MADRAS WATER-WORKS.

REPORT OF THE COMMITTEE

**COMMITTEE APPOINTED IN G.O. No. 1576 M.,
15TH SEPTEMBER 1917.**

1918.

MADRAS WATER SUPPLY SECTION OF ROUGHING FILTER

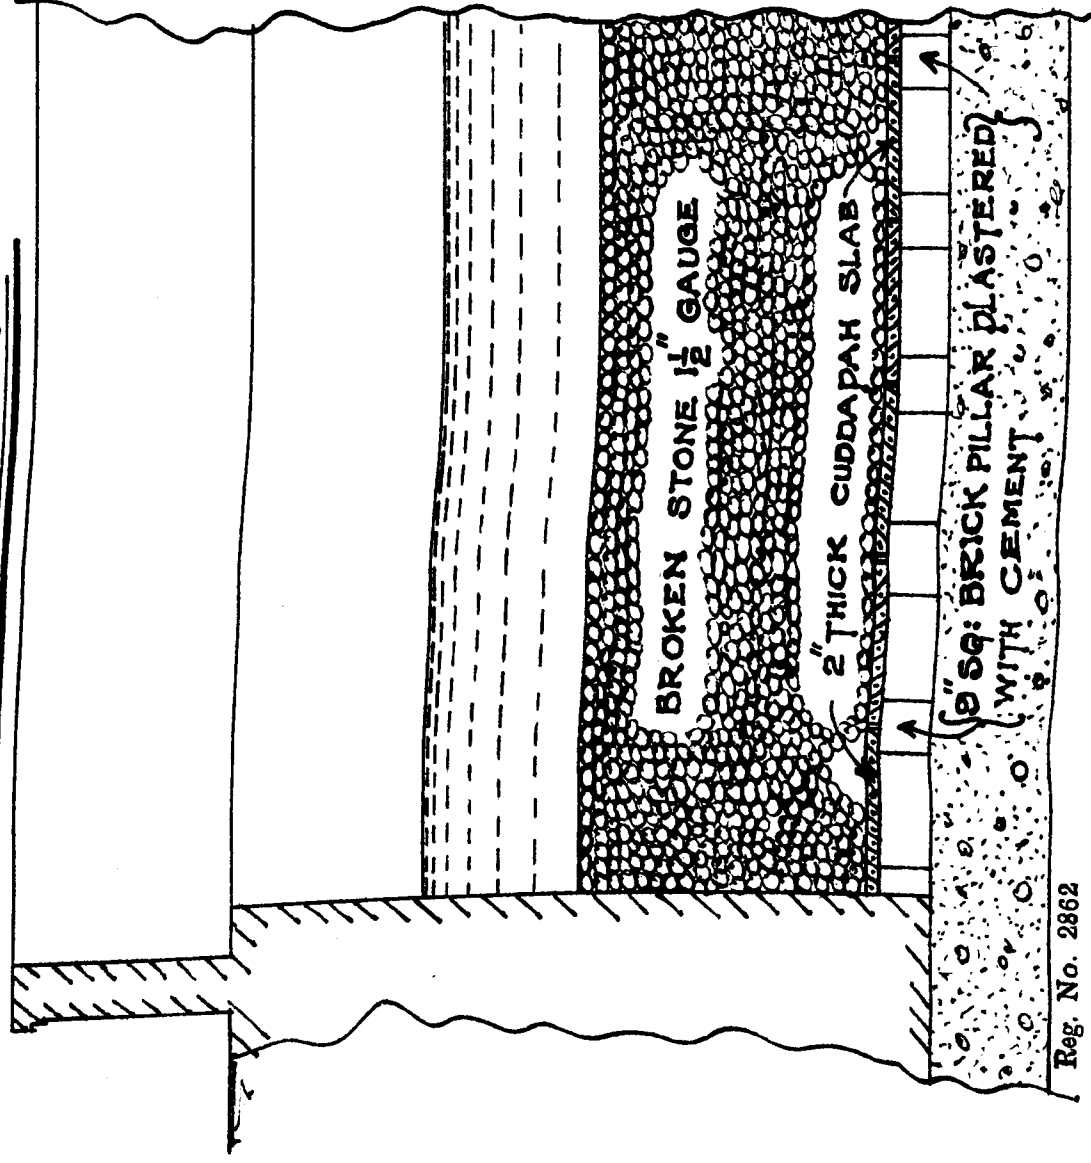
The Committee have referred to the roughing filters in some detail in a previous paragraph. Since their inspection the materials inside have been removed and the two compartments are now used as sedimentation and sunning basins prior to the water entering the conduit. The appendices which give the results of the bacteriological analyses show the improvement which has resulted from this operation in the quality of the water. We would remark that both compartments should be periodically cleaned at least once in six months and the inside cement washed or washed with freshly-slaked lime.

• MADRAS • WATER • SUPPLY • SECTION • OF • FILTER • BED • AS • IN • ORIGINAL • SKETCH •

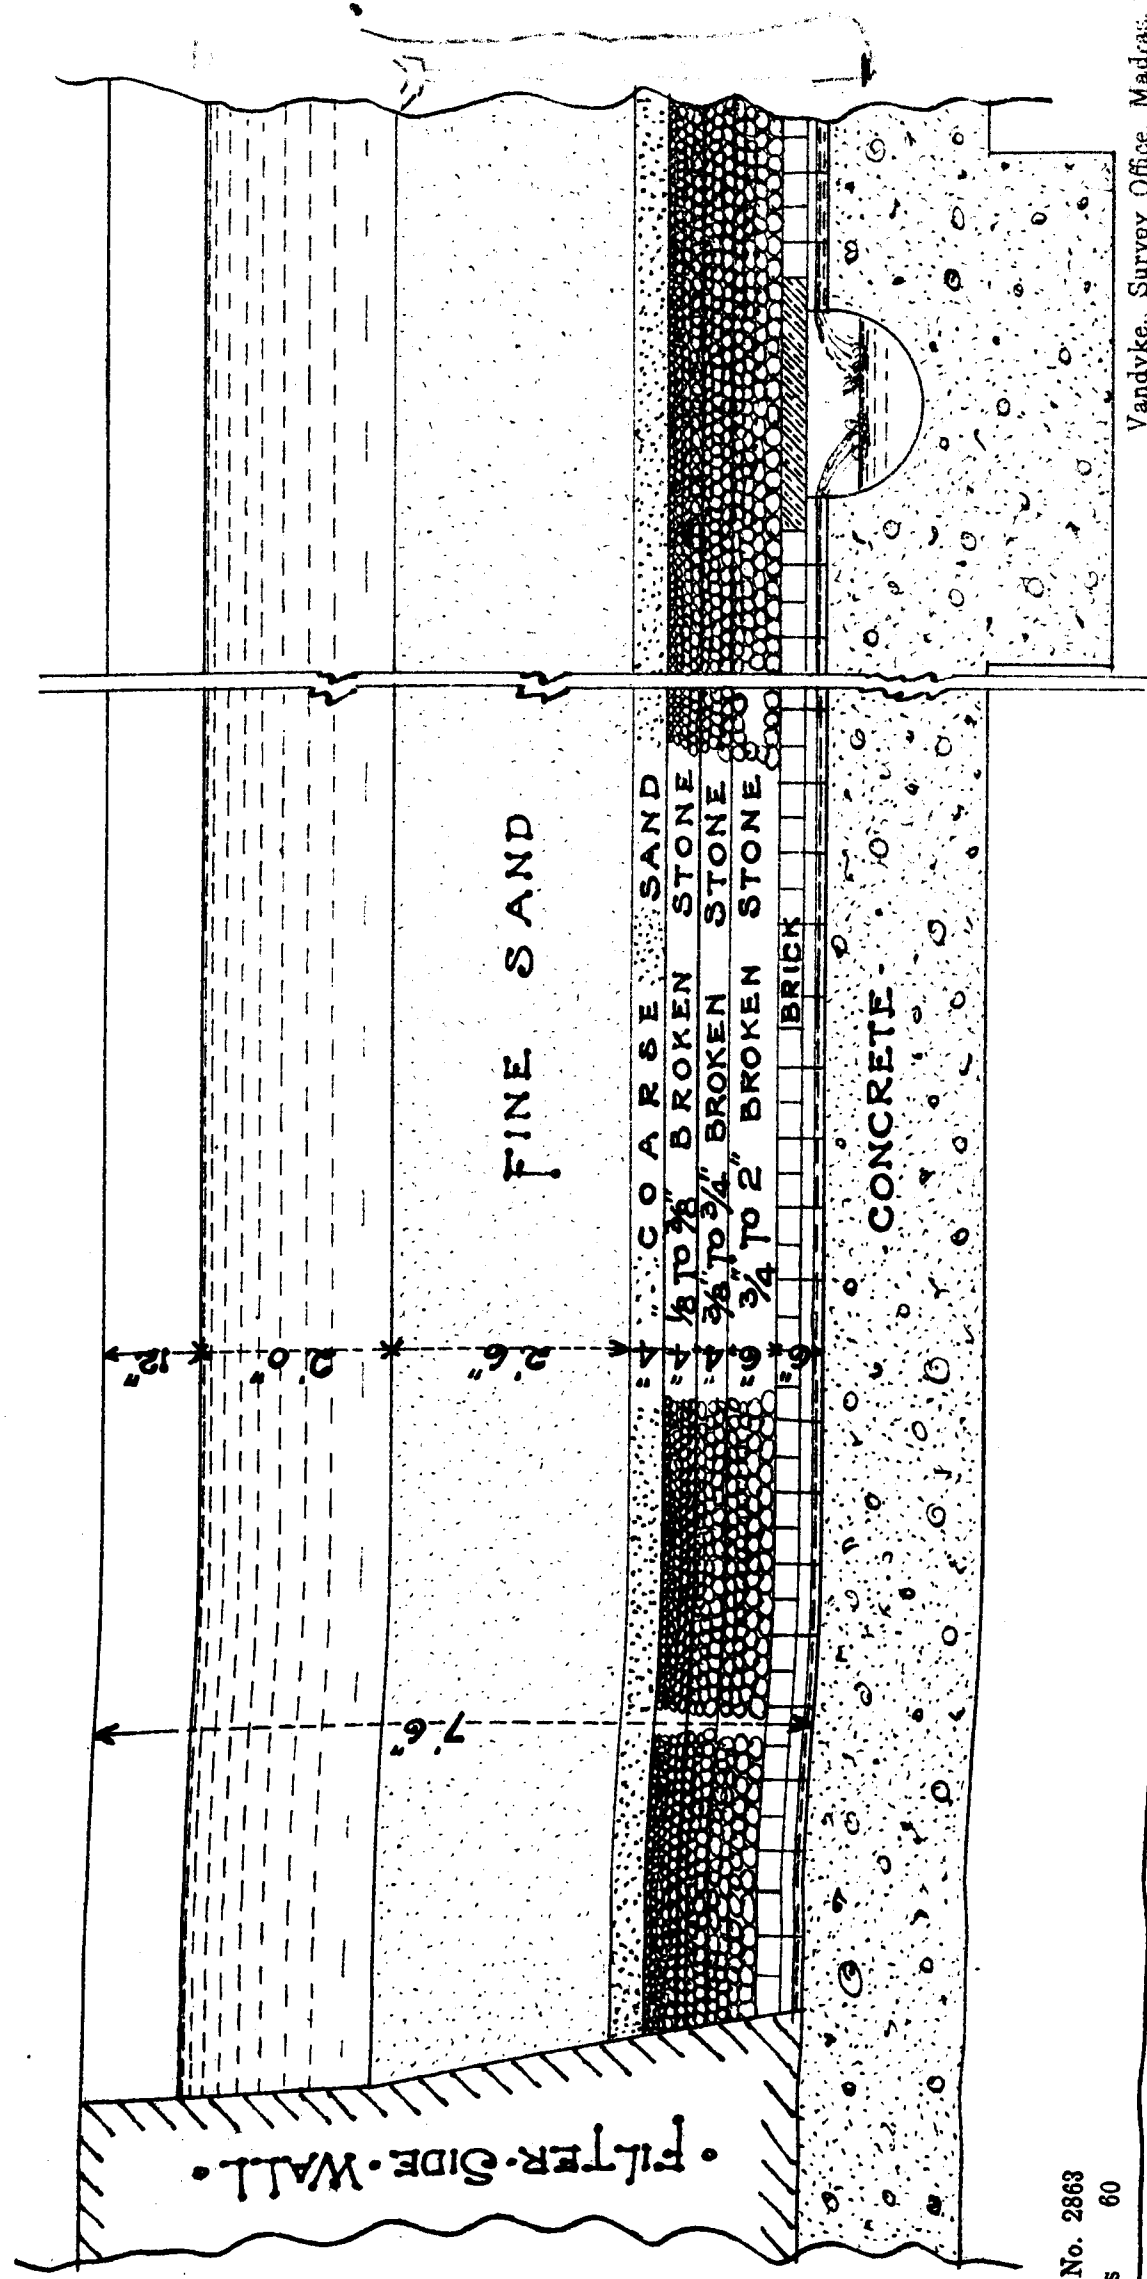
The thickness of the layer of broken stone in the Madras filter beds including a coarse sand layer of 4 inches was 18 inches in the original scheme. See plan No. 3. In the scheme as executed this provision has been cut down to 6 inches including a coarse sand layer of 2 inches. See plan No. 4. We are aware that the trend of opinion of the proper thickness of broken stone layer in a sand filter bed is in favour of reducing it to a minimum on the plea that this layer serves only the purpose of supporting the superimposed fine sand filtering layer. While admitting that this is an important function of the broken stone layer we are convinced that another important function of this layer is to facilitate the passage of filtered water from the sand layer to the underdrains and that consequently the thickness of this broken stone layer cannot be unduly reduced; especially is this so with the treatment of a water like the Madras water which contains a high organic matter content. We consider that the extension of the brick drains and broken stone layer to the walls of the filter is immediately essential removing at the same time the sand impregnated with black silt and substituting clean sand. In addition when all the sand of a filter bed is removed for periodical renewal it would be advisable to increase the thickness of the broken stone 6 inches. The increased thickness should be composed of stone 1½ inches to ¾ inch. See plan No. 5.

• MADRAS • WATER • Supply • • SECTION • OF • FILTER • BED • IN • USE •

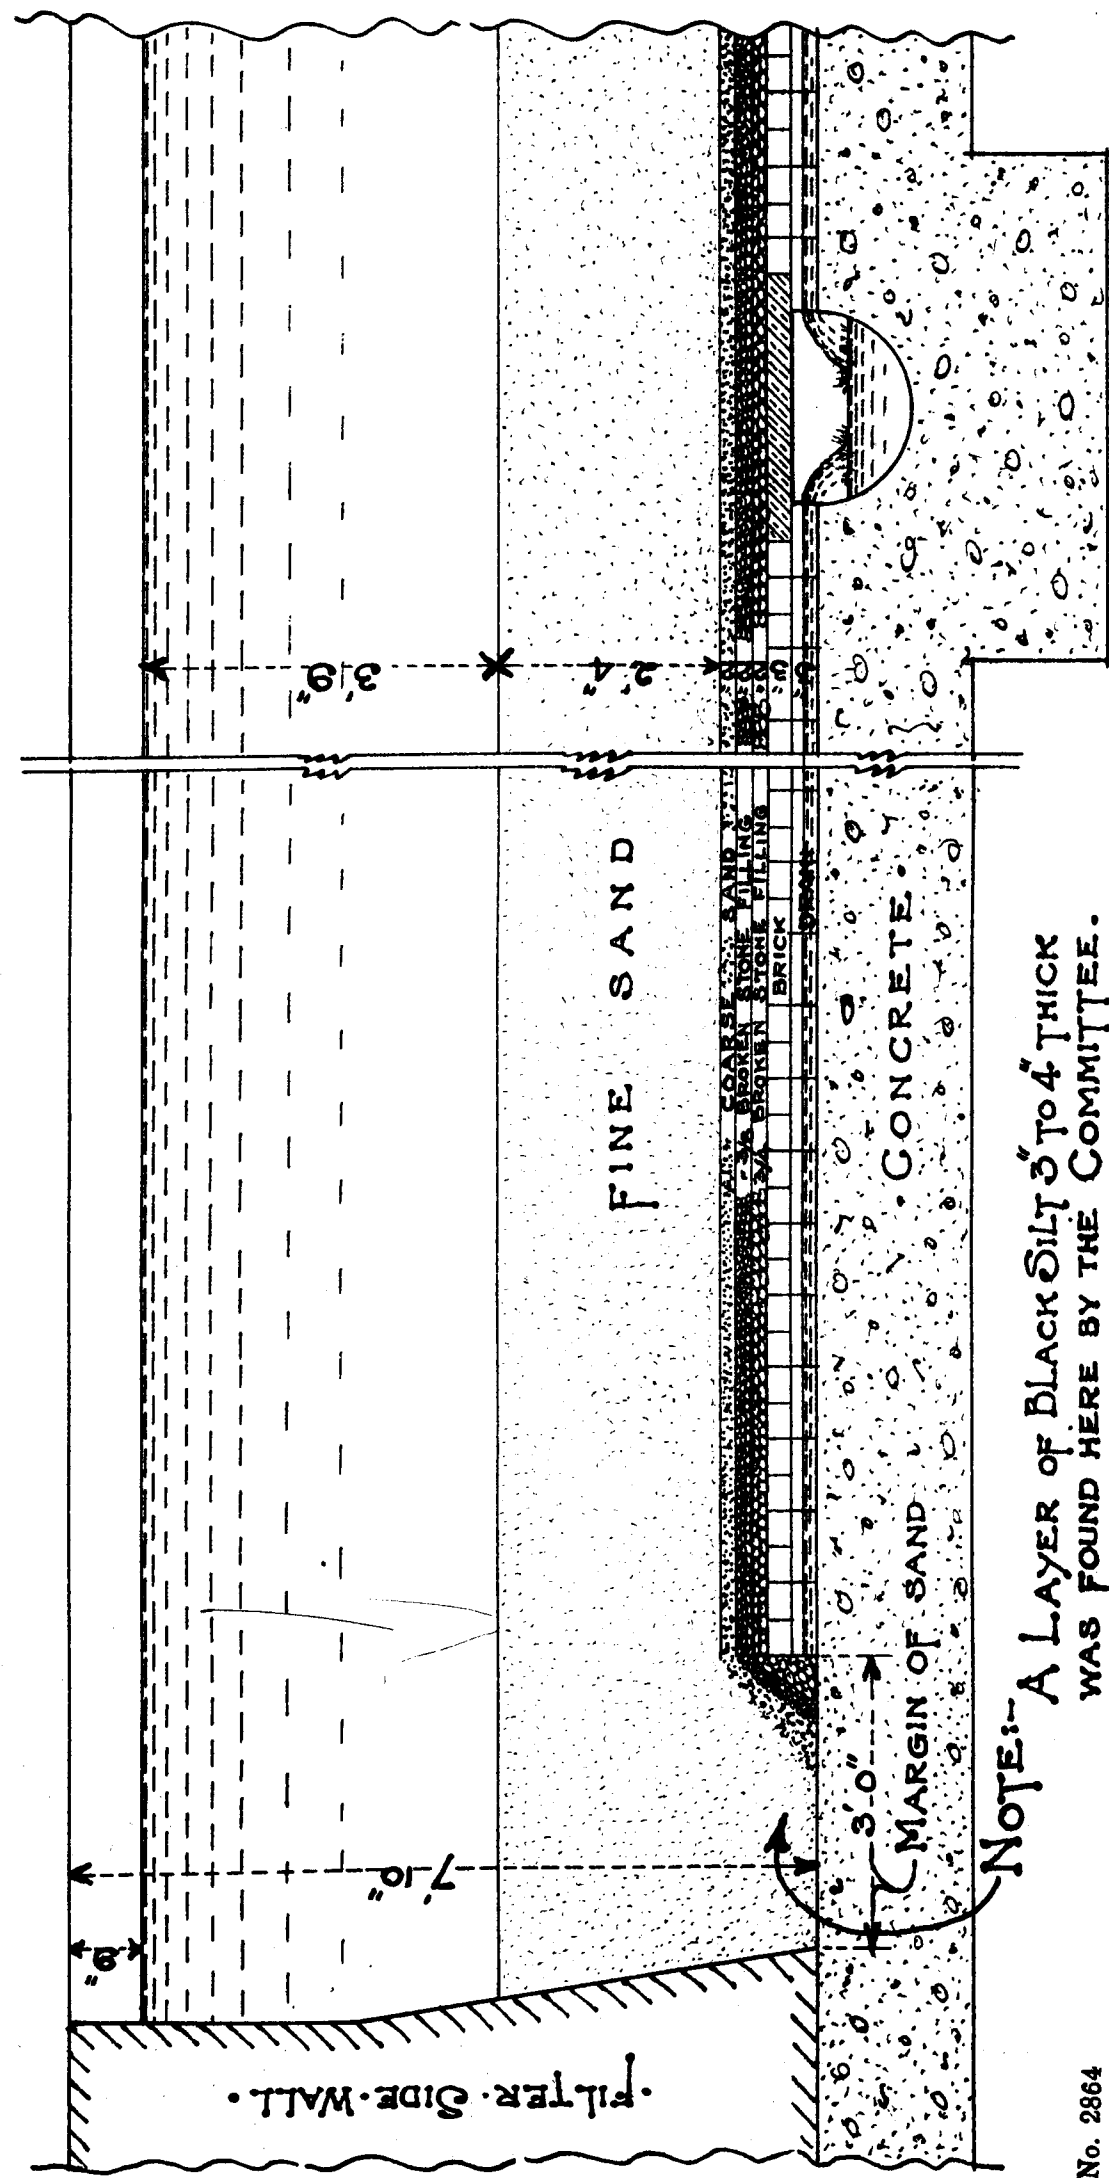
The broken stone and brick collecting drains and coarse sand layer in the Madras filters do not extend to the walls of the filter but a space three feet wide from the walls is filled with fine sand similar to two feet four inches sand layer. The Committee remark that this is not the customary way of filling in a filter bed. They were informed that it was done with the object 'to prevent short circuiting of the unfiltered water by creeping down the walls.' See plan No. 4.
